Seismic Walkdown Checklist (SWC)

Equipment ID No. H21P081 Equip. Class¹ 18, Instrument Racks

Equipment Description Div 2 EECS Trip Unit Instrument Rack

NJPR-12-0043

(DSC01090)

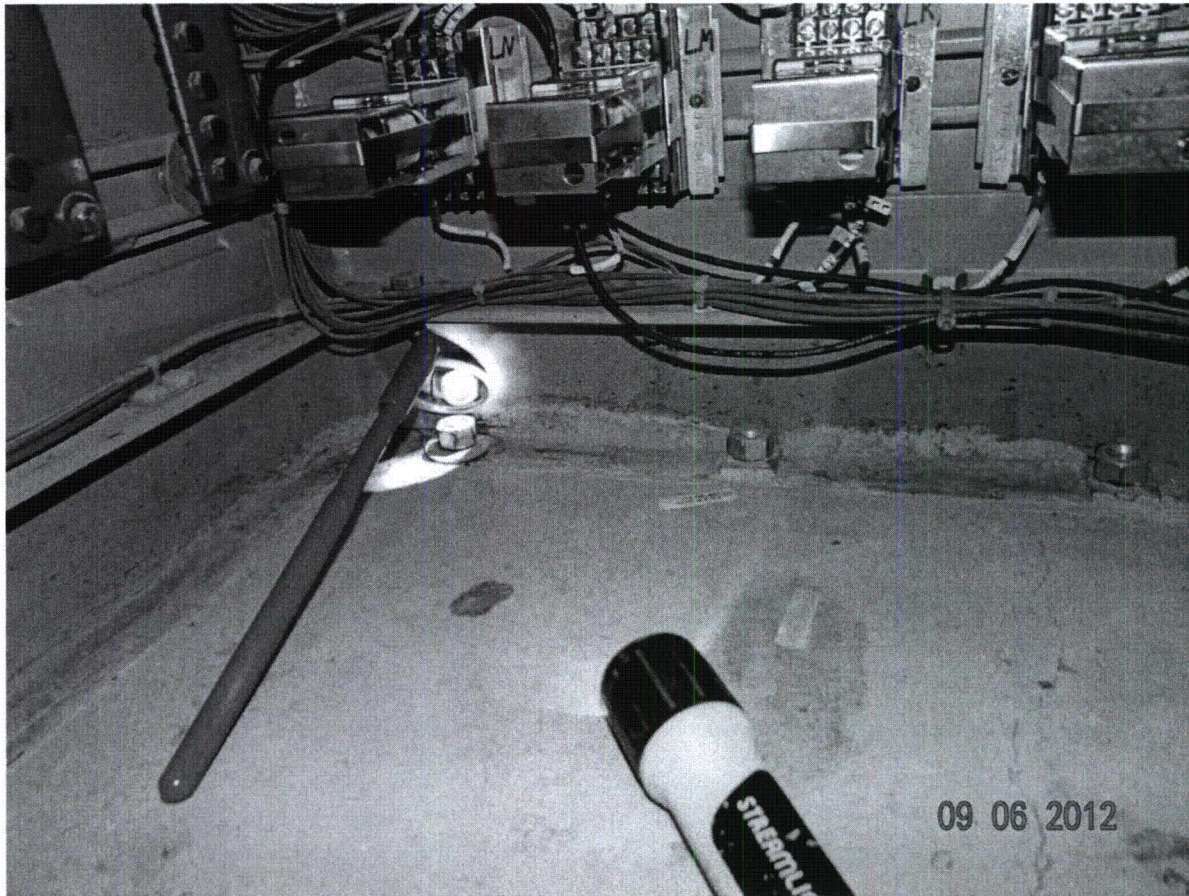
1. Is the anchorage configuration verification required (i.e., is the item one of the 50% of SWEL items requiring such verification)? Y N U
2. Is the anchorage free of bent, broken, missing or loose hardware? Y N U N/A
Thread engagement on some anchor bolts is less than one thread exposed from face of nut per Fermi Spec. 3071-226, Rev. K, Section 3.3.5.4(b). See attached "Hand sketch". Card 12-27702 was initiated to resolve this matter. Also, one bolt has a flat round washer instead of a square beveled washer (see photo DSC01090).

6. Based on the above anchorage evaluations, is the anchorage free of potentially adverse seismic conditions? Y N U
Item (2) - Some anchor bolts do not have full thread engagement per Fermi spec. 3071-226. & one bolt has a round washer instead of beveled washer. See attached "Hand sketch". CARD 12-27702 was initiated to resolve both issues (see photo DSC01090).

(DSC01092)
"Hairline Cracks"

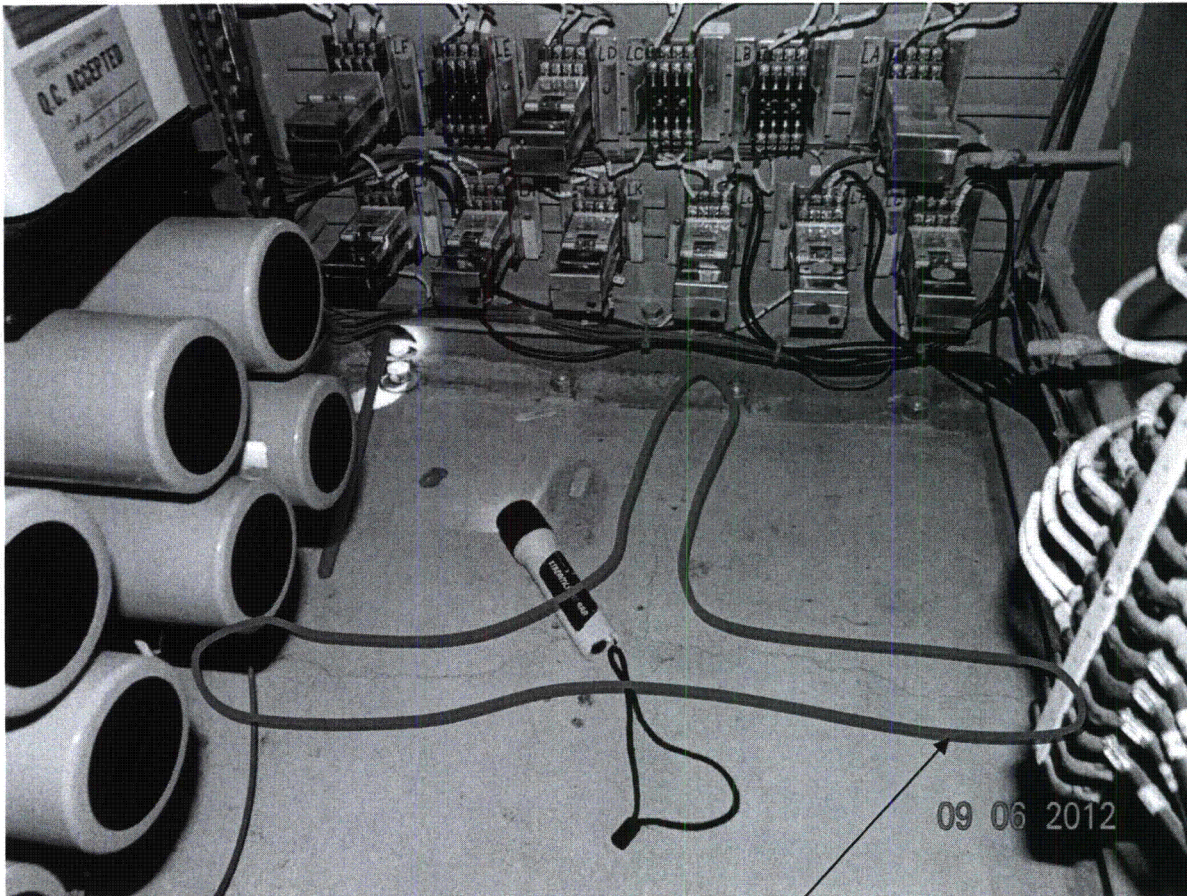
3. Is the anchorage free of corrosion that is more than mild surface oxidation? Y N U N/A
No corrosion or oxidation for the anchor bolts.
4. Is the anchorage free of visible cracks in the concrete near the anchors? Y N U N/A
Visible hairline cracks in the concrete inside the cabinet, within 2" of anchor bolt and also in front of cabinet. See attached "Hand sketch". The cracks are "Shrinkage" cracks and no impact on anchor capacity (see photo DSC01092).

(DSC01099)

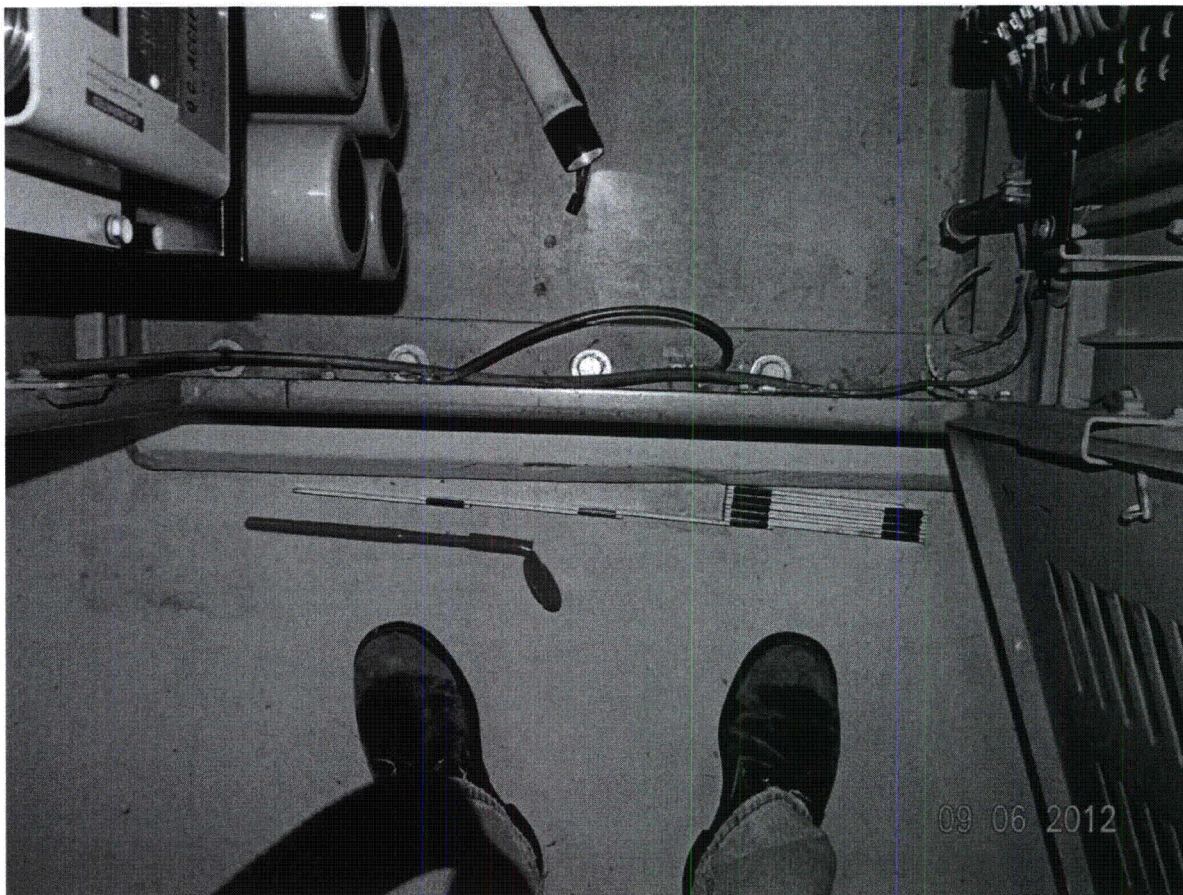
10. Based on the above seismic interaction evaluations, is equipment free of potentially adverse seismic interaction effects? Y N U
The equipment is free of potential adverse seismic interaction effects. The adjacent cabinets are bolted together side by side. No possibility of banging into each other (see photos DSC01099).

(Photo DSCN 0294)

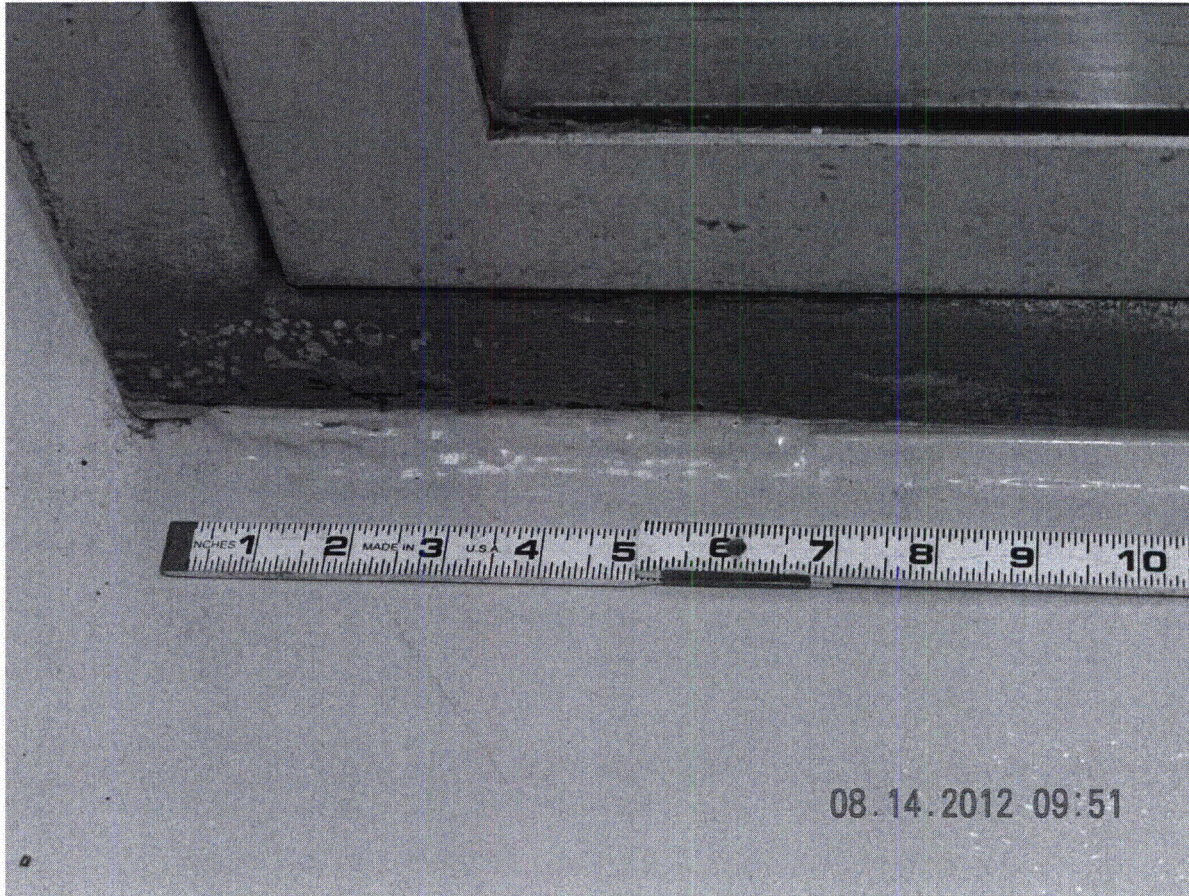
4. Is the anchorage free of visible cracks in the concrete near the anchors? Y N U N/A
Concrete around embedded plates is free of cracks (see Photo DSCN 0294).

(Photo DSCN 0300)

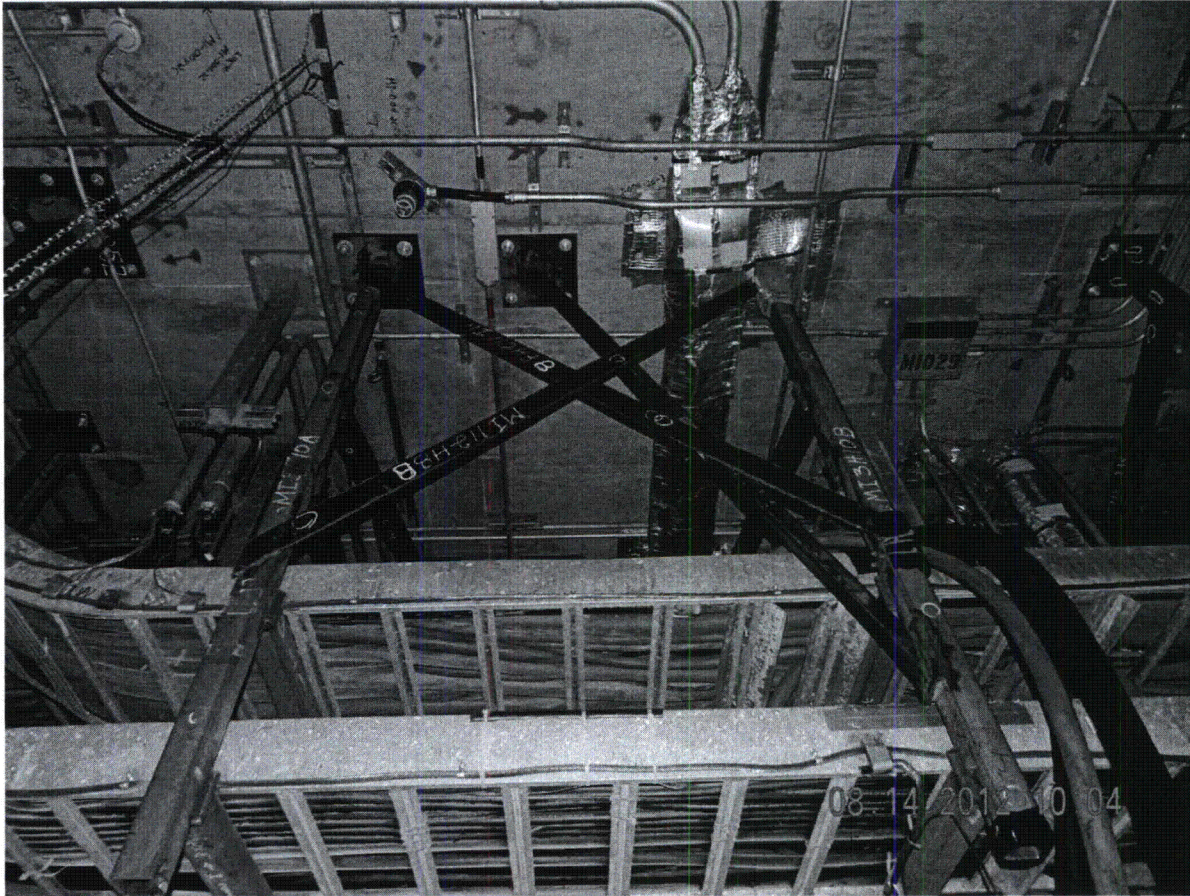
9. Do attached lines have adequate flexibility to avoid damage? Y N U N/A
Top entry cables are looped to provide flexibility (see Photo DSCN 0300).
10. Based on the above seismic interaction evaluations, is equipment free of potentially adverse seismic interaction effects? Y N U
Adjacent switchgear cabinets, 72B-2A and R3101S001, are welded front and rear to embedded plates. Therefore, separation is acceptable. Panel H21P628 is approximately 10" away. Per EPRI guidance for rigidly supported equipment, only 2" of separation is required. Therefore, 10" of seismic separation is acceptable.

(Photo DSCN 0318)

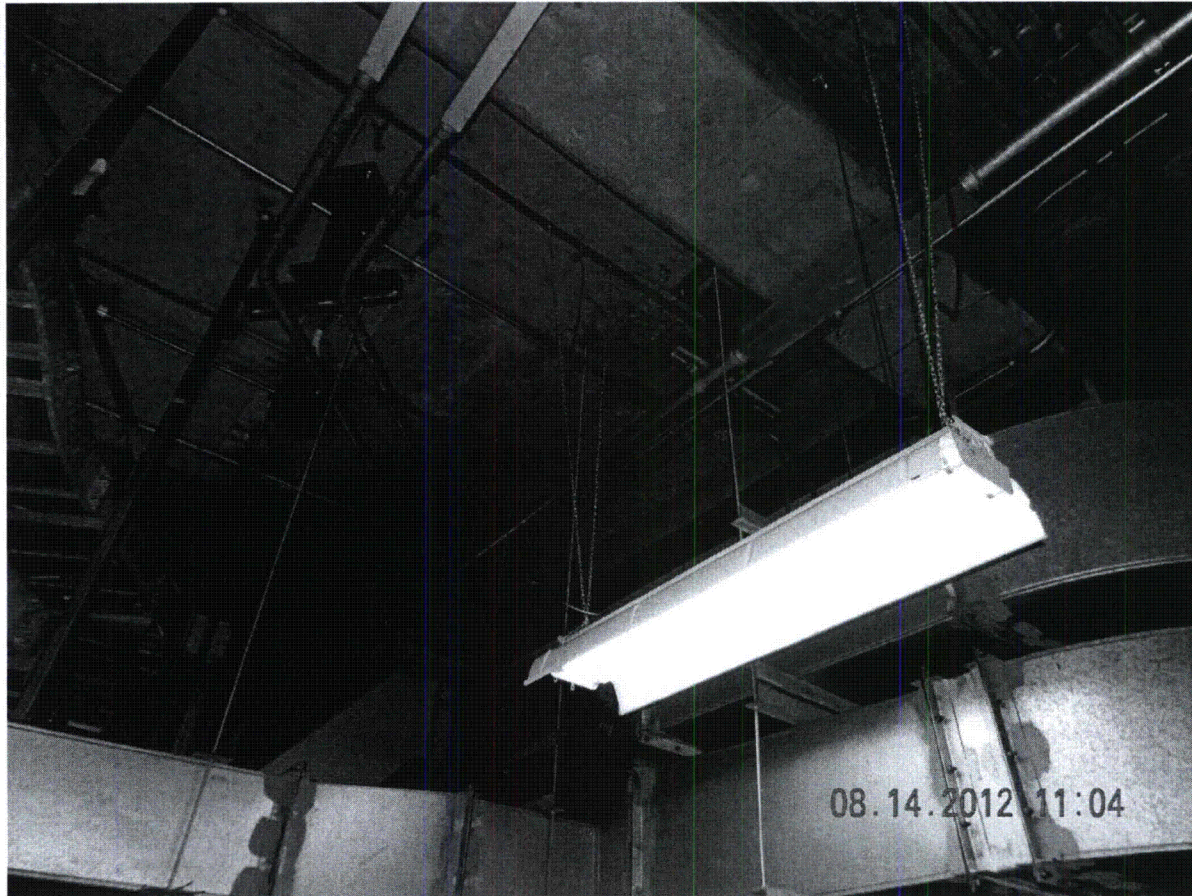
8. Are overhead equipment, distribution systems, ceiling tiles and lighting, and masonry block walls not likely to collapse onto the equipment? Y N U N/A
Lights are supported by cable and chains or unistrut brackets (see Photo DSCN 0318). There are no block walls close by.

(DSC 00280)

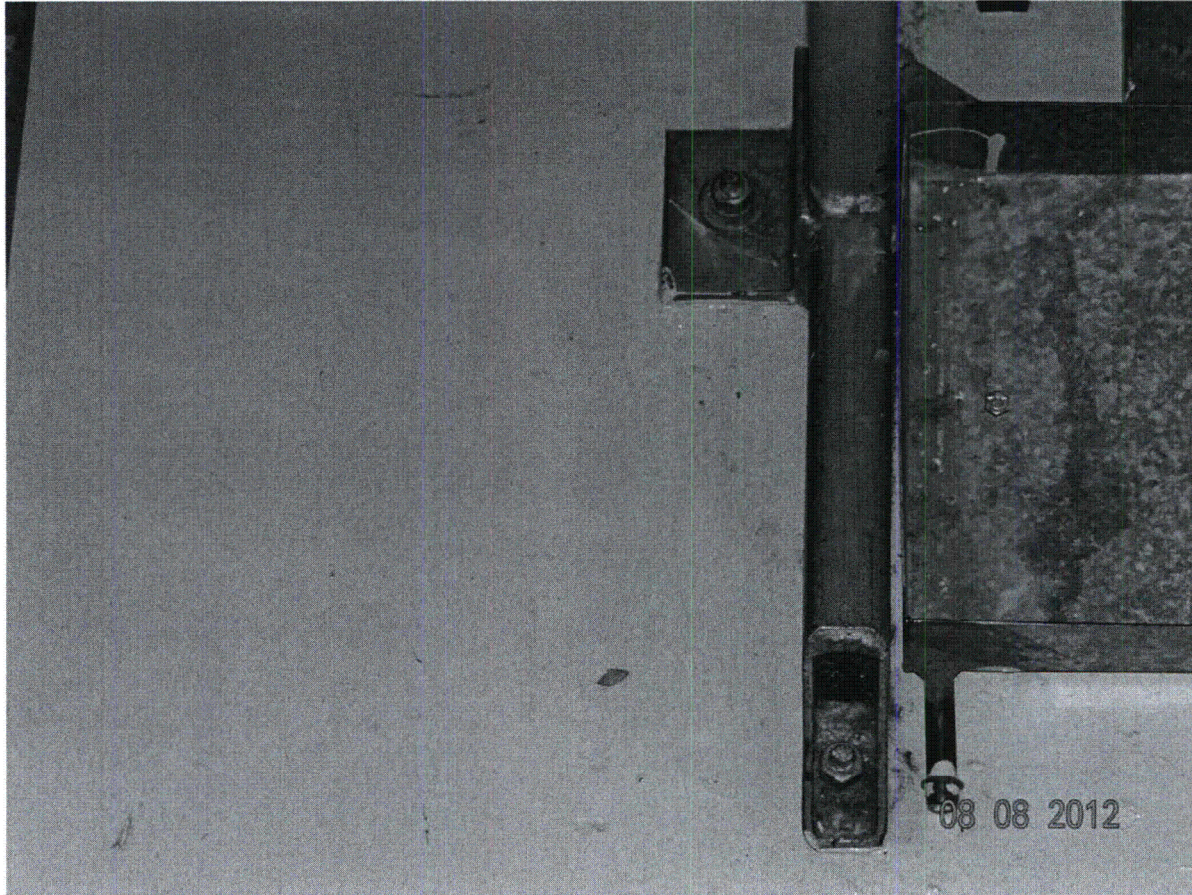
5. Is the anchorage configuration consistent with plant documentation? Y N U N/A
(Note: This question only applies if the item is one of the 50% for which an anchorage configuration verification is required.)
Anchor configuration is consistent with Dwg. I-2525-25, Rev. E. (See Photos DSC00275, 00279, 00280 and 00283) No postings ✓ DJK 10/12/12

(Picture 66)

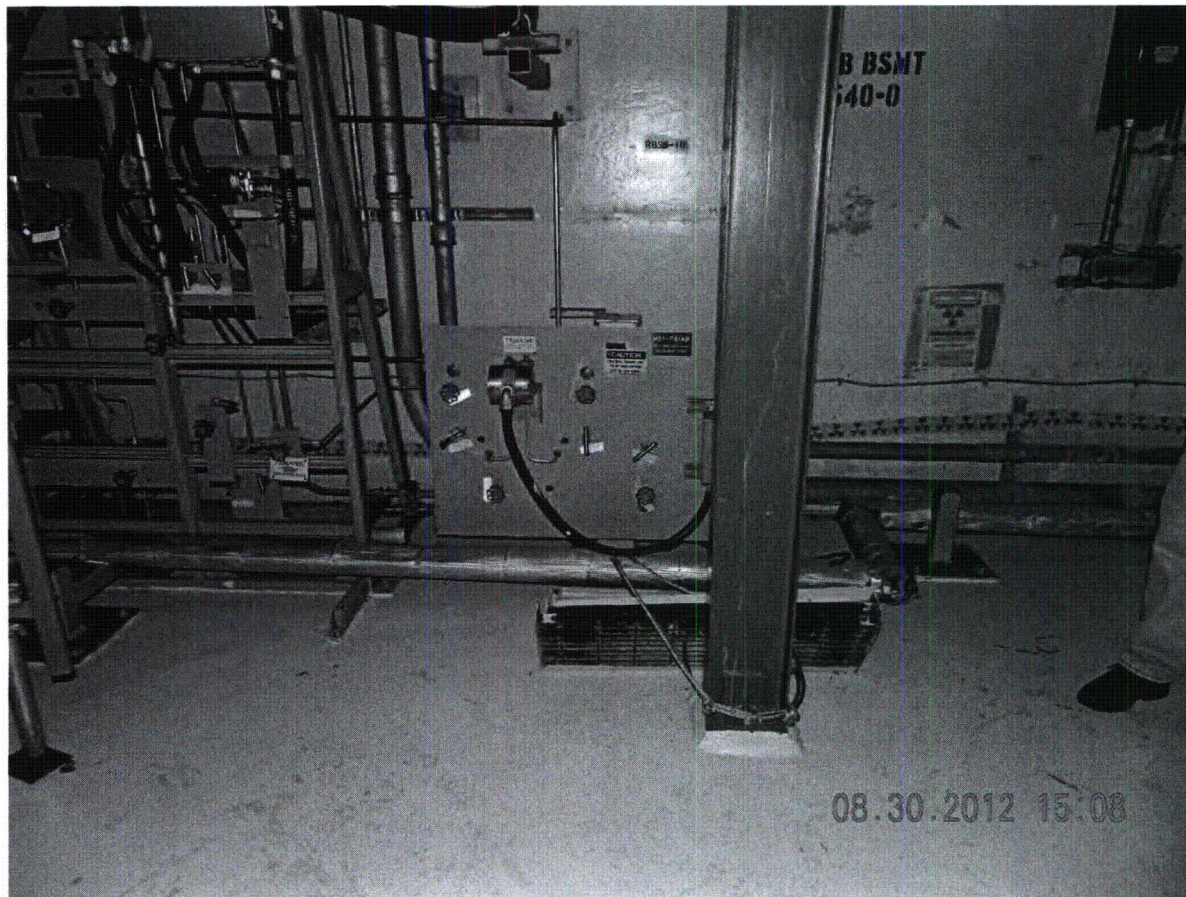
7. Are soft targets free from impact by nearby equipment or structures? Y N U N/A
There are no observed impact sources nearby. See pictures 66 & 67 for general area.
8. Are overhead equipment, distribution systems, ceiling tiles and lighting, and masonry block walls not likely to collapse onto the equipment? Y N U N/A
There are no ceiling tiles, masonry block or other realistic hazards in the area. Note the overhead view in Picture 65.
9. Do attached lines have adequate flexibility to avoid damage? Y N U N/A
Attached lines are either made of flex conduit or are looped to provide adequate flexibility. (See Pictures 58 and 67)
10. Based on the above seismic interaction evaluations, is equipment free of potentially adverse seismic interaction effects? Y N U
No adverse seismic conditions due to interaction effects were observed.
-
